PSB#021584 Status of the Large 3-ring (RW-1-82; RW-1-83) February 15, 1984

NUMBER: 3

DATE: FEBRUARY 15, 1984

TO: ALL OWNERS AND CURRENT USERS OF THE 3-RING RELEASE SYSTEM SUBJECT: STATUS OF THE LARGE 3-RING

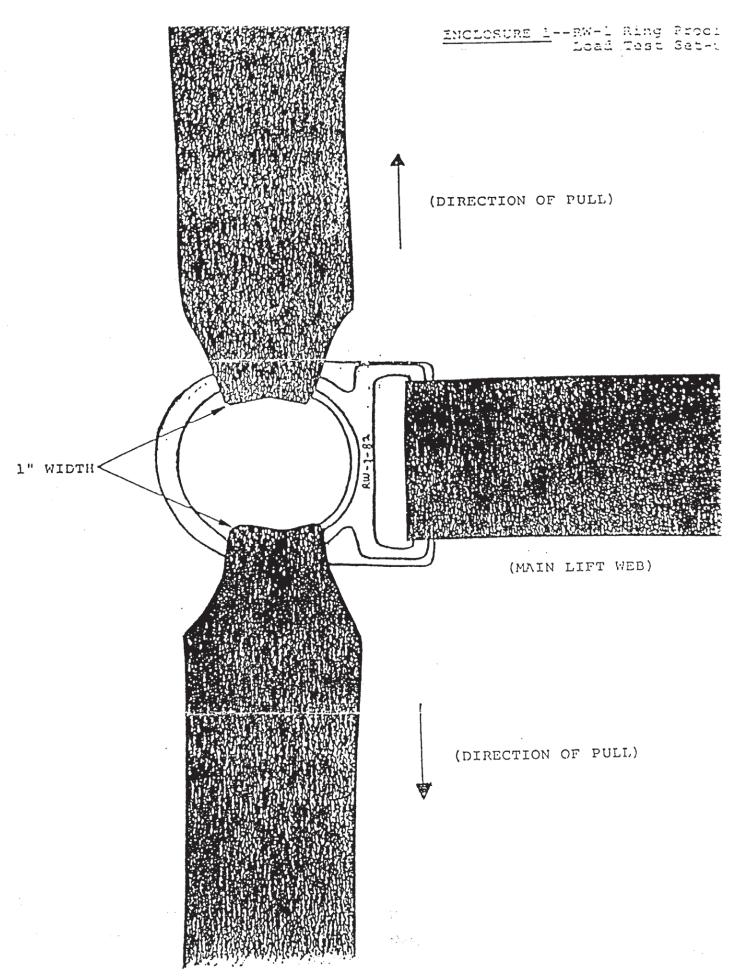
- b. OPTION #2 TEST ALL SUSPECT RINGS. An FAA Master or Senior Rigger is authorized to certify that suspect rings are not defective as follows:
- (1) Using a Tinius Olsen or other suitable pulltesting devise, pull in opposite directions against each side of the round portion of the ring using 1" tubular nylon webbing, or either Type VII or Type VIII nylon webbing folded under to a width of 1" (See Diagram 1).

- (3). Harnesses using rings which have been tested and are found to be acceptable, must be designated by permanently affixing a rigger's seal (with symbol) using wire (not red

rigger's thread) to the right ring's webbing slot. The seal must be attached to the square portion of the ring through which the main lift web passes, not the round portion.

- (2). Subject each load to a 2500 lb. (1134 kg.) proof load. Measure the I.D. of the large'ring prior to testing with a micrometer, load the ring to 2500 lbs., relax the load, and remeasure the ring. Rings which show no deformation more than 0.020 inches are acceptable. Any ring showing deformation more than 0.020 MUST BE REPLACED. (NOTE #1: Defective rings will noticeably distort when loading reaches approximately 2000 lbs. (907 kg.) and stay distorted when tension is relaxed. NOTE #2: If pull test is conducted using two metal bars in place of webbing loops and test is conducted at 90 degrees to normal hardware loading (as shown in drawing), then a 2500 lb. load may stretch normal good hardware. Therefore, a 2000 1b. load will be sufficient to certify a ring as good in this case).

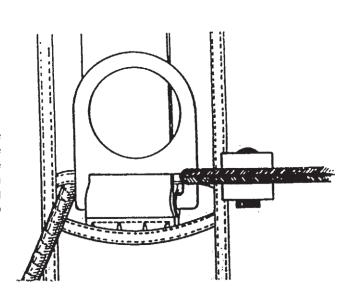
Prepare rig and working area. This operation is best done on a flat hard surface such as the floor or a sturdy workbench. Remove main risers. Lay rig flat on working area and pull straight up on ring to be cut. Keep rig and surrounding webbing as far away as possible from the rest of the rig during the entire process. Make both cuts on the same side of the ring.

Make both cuts on the same side of the ring.

Push webbing as far away as possible from the area to be cut. Use only the very tip of the bolt cutters nd set the edge at the very top of the slotted ction of the ring (see cutting guide illustration). When the bolt cutters are in place, place a neavy towel over the area to be cut. The.ring will usual ly stay put, but occasional ly pieces can go flying; the towel will keep everything in place.
